Attachment 9
NRC3-12-0003
(17 pages)

Response to RAI Letter No. 70
(eRAI Tracking No. 6244)

RAI Question No. 03.07.01-7

Figure 8: CB horizontal estimated 2% damped FIRS compared to the 2% damped spectrum for the CB H1 SSI time history.

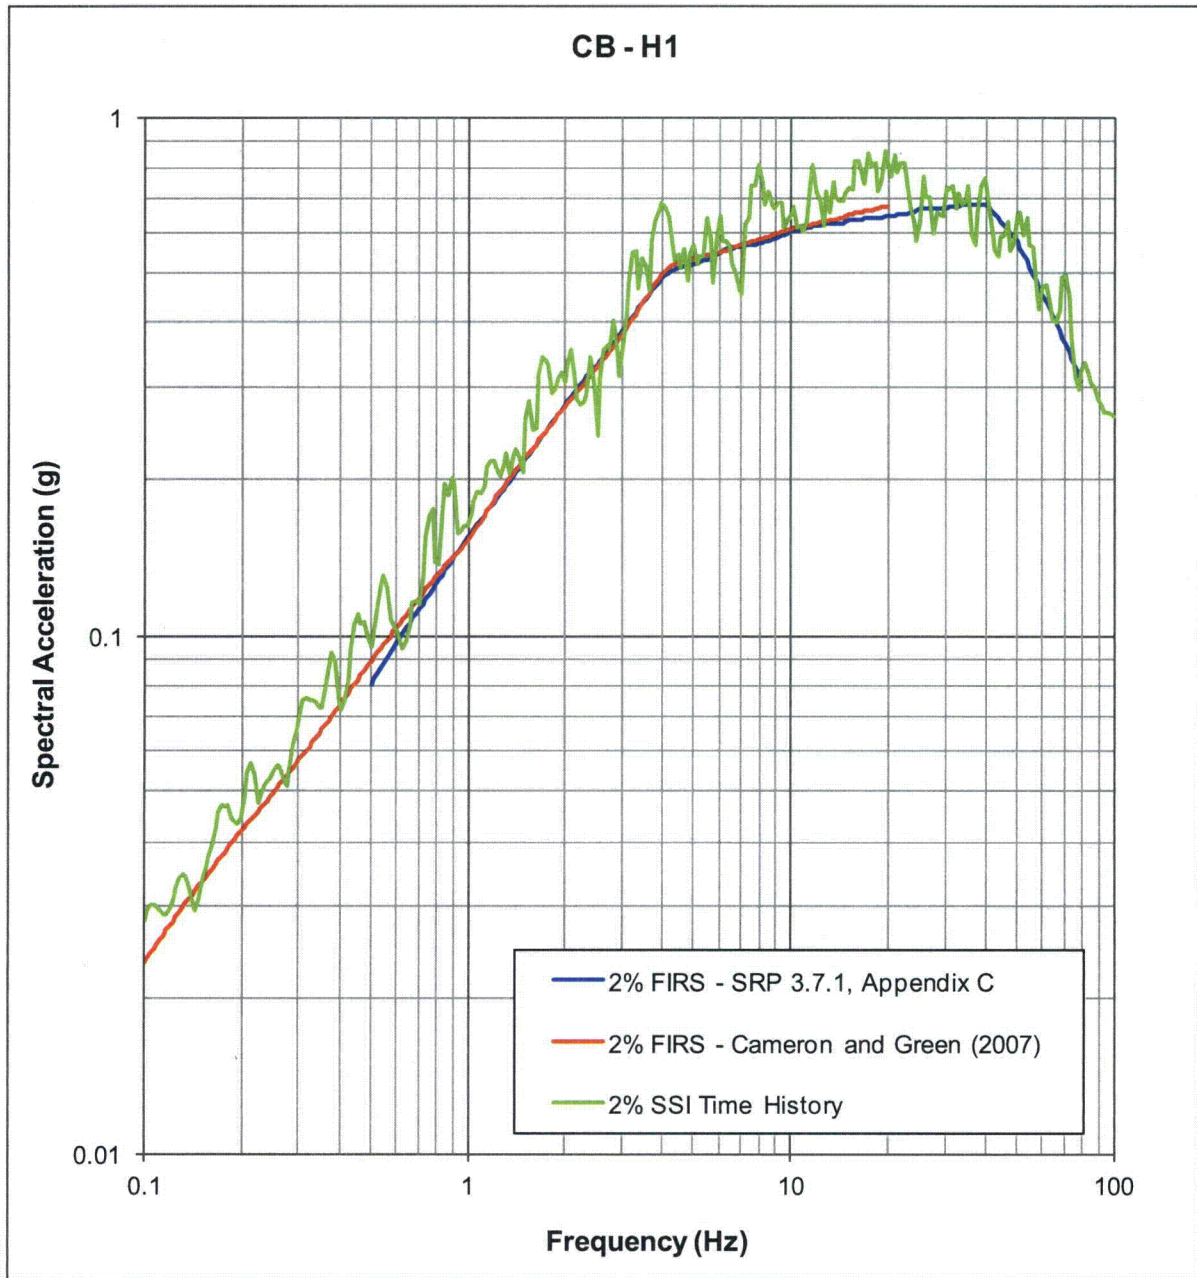
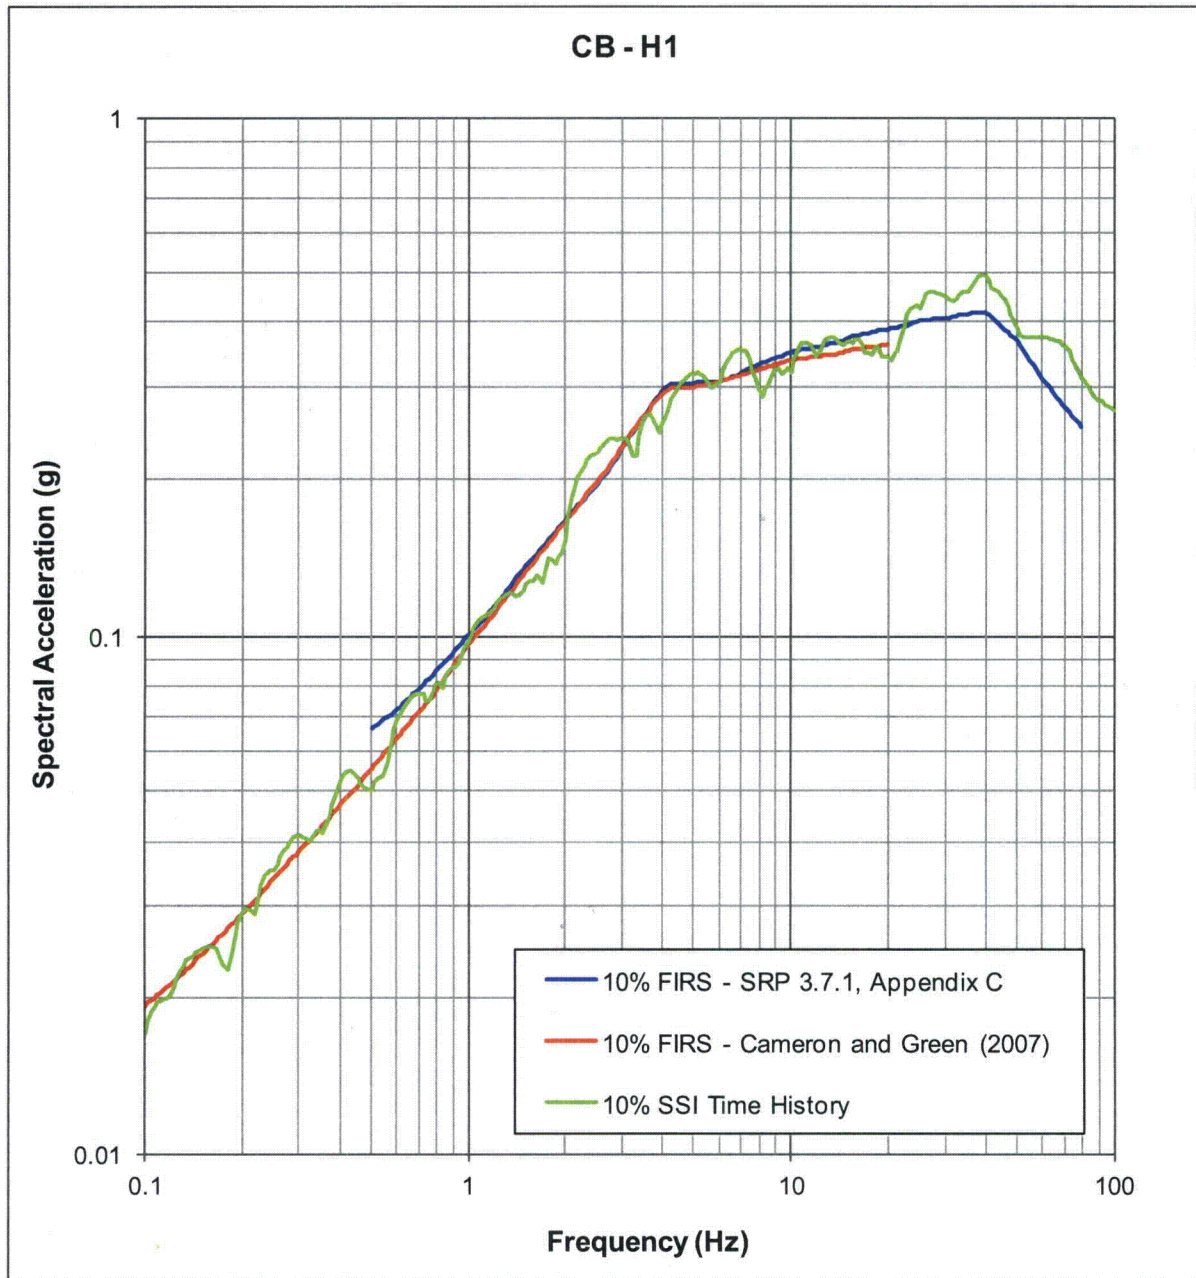
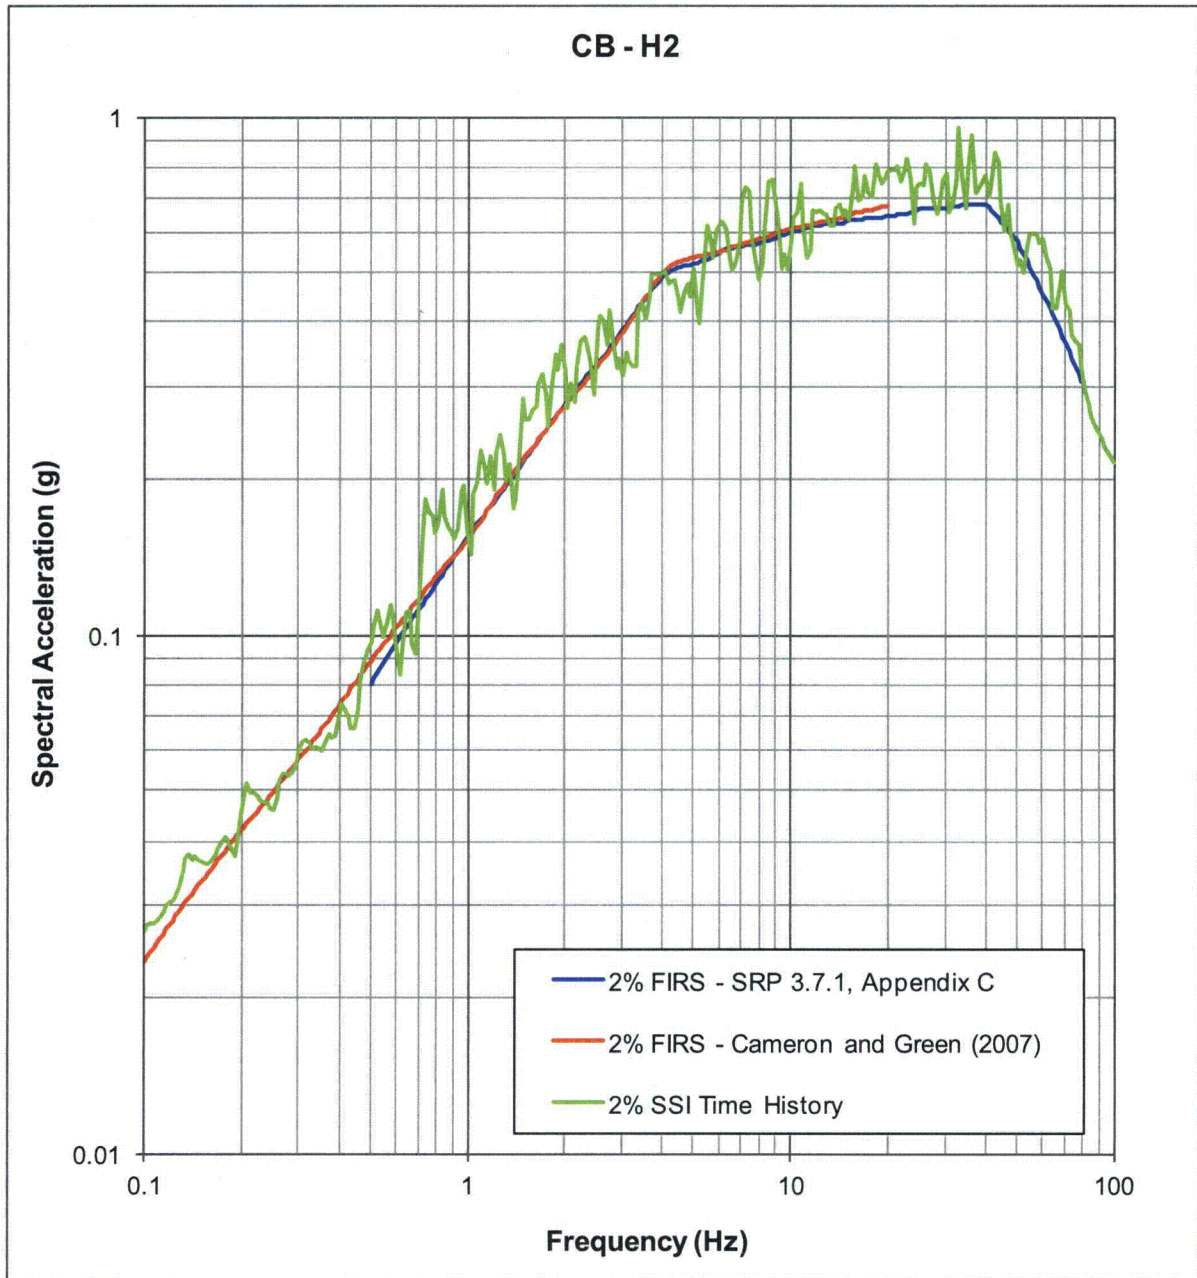
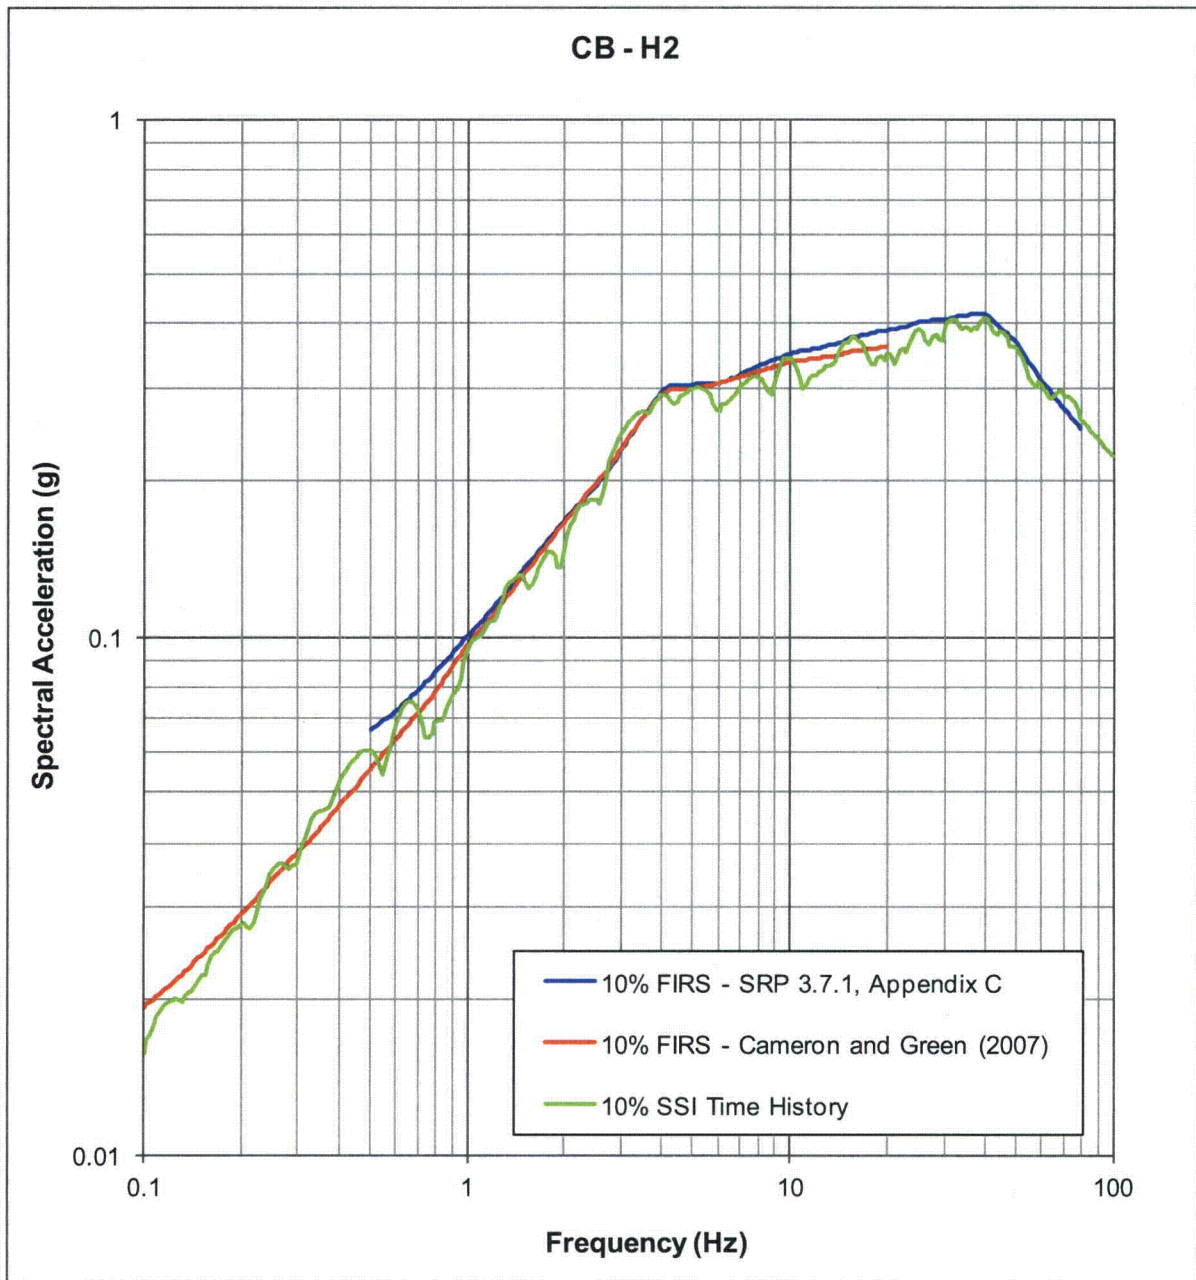
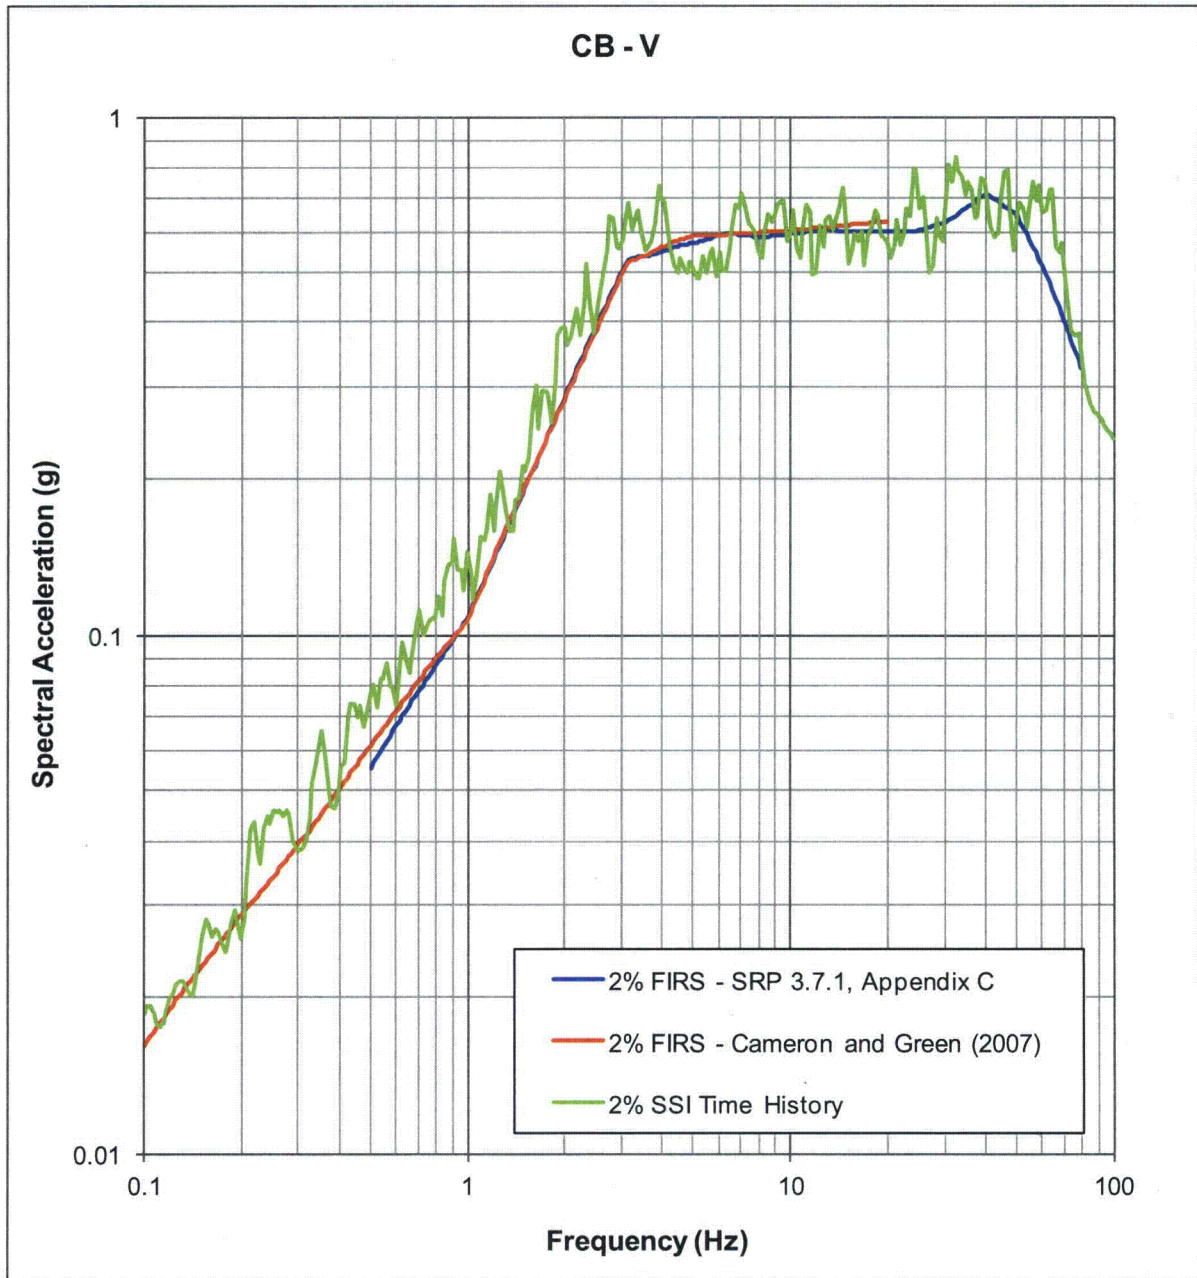
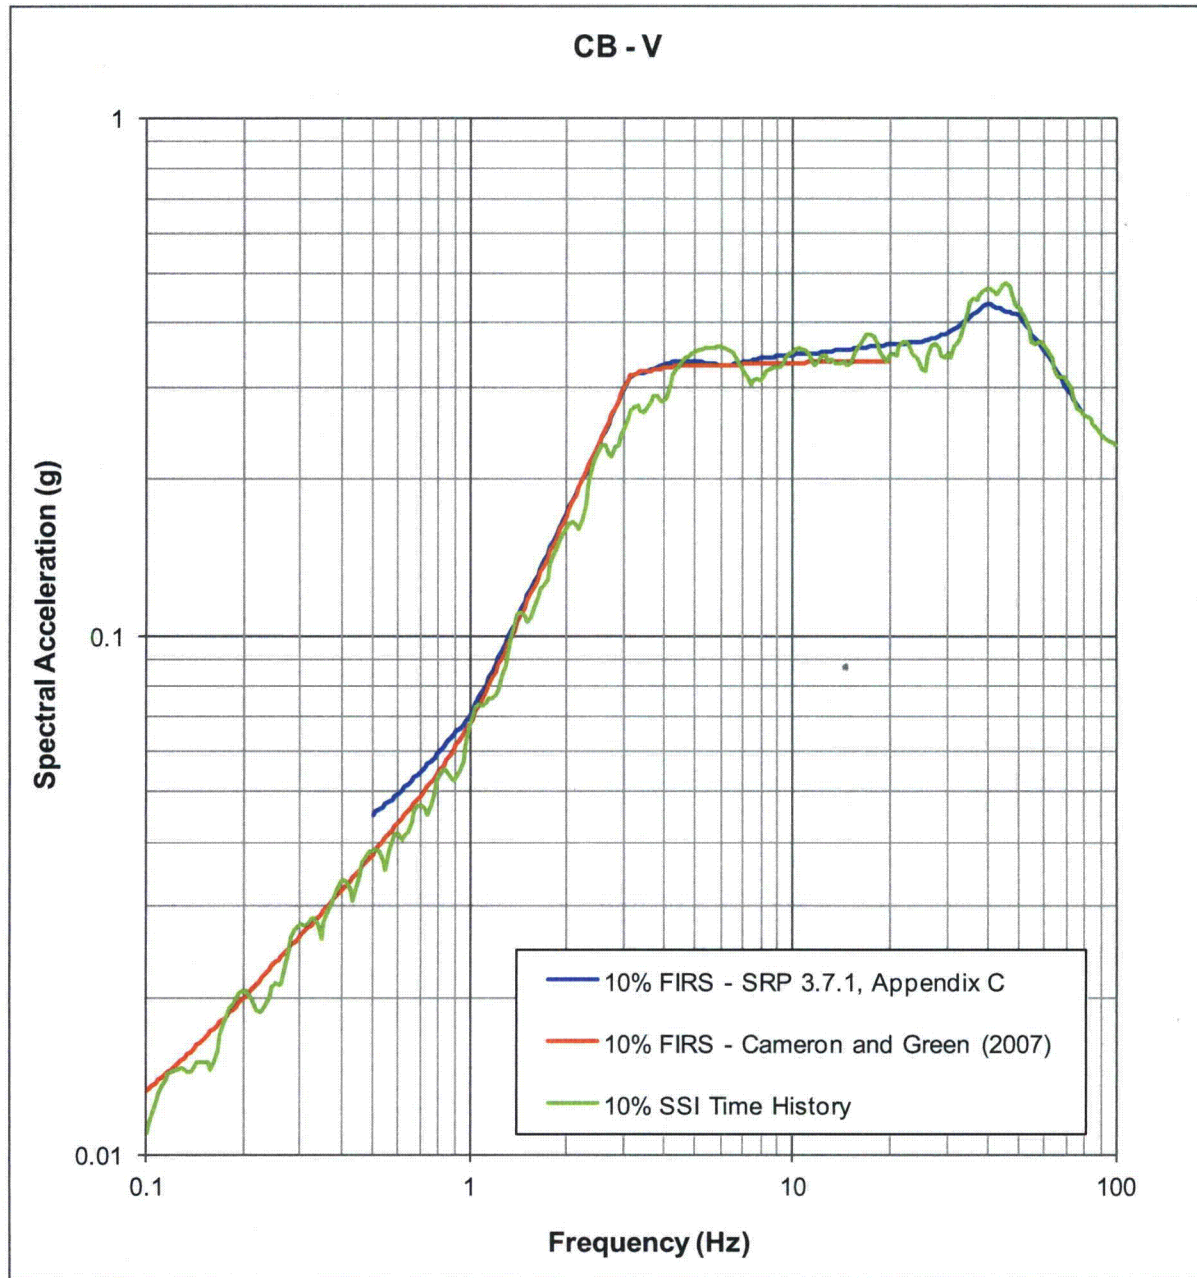
SRP Acceptance Criteria 3.7.1.II.1B also specifies that PGV/PGA should be consistent with the characteristic values for the controlling earthquake. As such, the applicant is requested to provide further justification of the acceptability of the PGV/PGA values for the artificial time histories being higher than the selected controlling earthquake. The applicant is also requested to provide comparison of the response spectra of the artificial time histories and the estimated target spectra (SSI FIRS) at 2 percent and 10 percent damping values for RB/FB and CB.

Figures 2 through 13 show the RB/FB and CB SSI FIRS scaled to 2 percent damping and 10 percent damping. Shown on each of the plots is the corresponding 2 percent or 10 percent damped spectrum for an individual SSI time history. The time history spectra are in good agreement with the scaled FIRS.

Figure 1: Comparison of Fermi 3 RB/FB and CB SSI FIRS with the NUREG/CR-0098 median rock spectral shape and enveloping NUREG/CR-6728 CEUS spectral shape, both scaled to a minimum PGA of 0.1g. All spectra are for 5% damping.

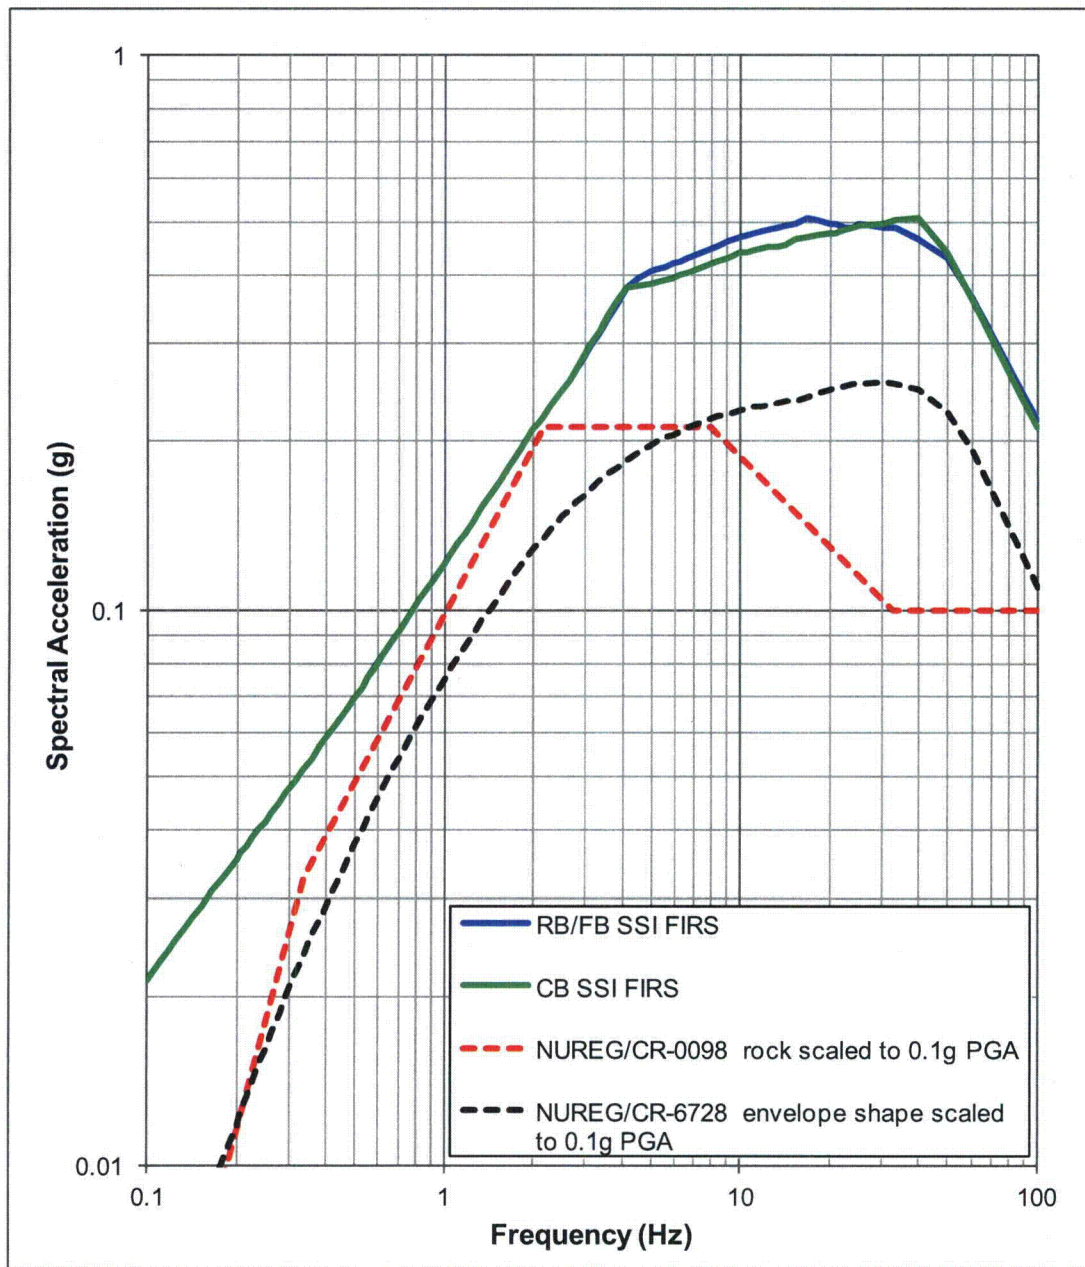
However, the guidance in SRP 3.7.1 and ISG-017 also indicates that, to satisfy the regulatory requirements, the minimum horizontal PGA of 0.1g should correspond to a smooth broad-band spectral shape such as the one described in RG 1.60. Therefore, the applicant is requested to provide in the FSAR comparison plots of the RB/FB and CB horizontal FIRS with the RG 1.60 horizontal spectrum anchored at 0.1 g, which demonstrate that the RB/FB and CB horizontal FIRS envelope the RG 1.60 spectrum at all frequencies of interest. The staff needs this information to confirm that the site-specific seismic input used in the site-specific SSI analysis meets 10 CFR Part 50, Appendix S.

The Regulatory Guide (RG) 1.60 spectral shape was derived from statistical analyses of strong motion records obtained primarily at deep soil sites in the western United States (NUREG/CR-6926, Section 3.1). As the Fermi 3 RB/FB and CB are to be founded on relatively hard rock (Bass Islands Group with a shear wave velocity of 6,650 fps [2027 m/s]) in the central and eastern United States (CEUS), the RG 1.60 spectral shape is not considered appropriate. At a minimum, a rock site spectral shape should be considered. For example, NUREG-1407 (Chen et al., 1991) utilized the median response spectral shape for rock sites developed in NUREG/CR-0098 (Newmark and Hall, 1978) to characterize ground motions for CEUS nuclear power plants founded on rock. Figure 1 shows that the median NUREG/CR-0098 response spectral shape for rock sites scaled to 0.1g PGA is enveloped by the Fermi 3 SSI FIRS.
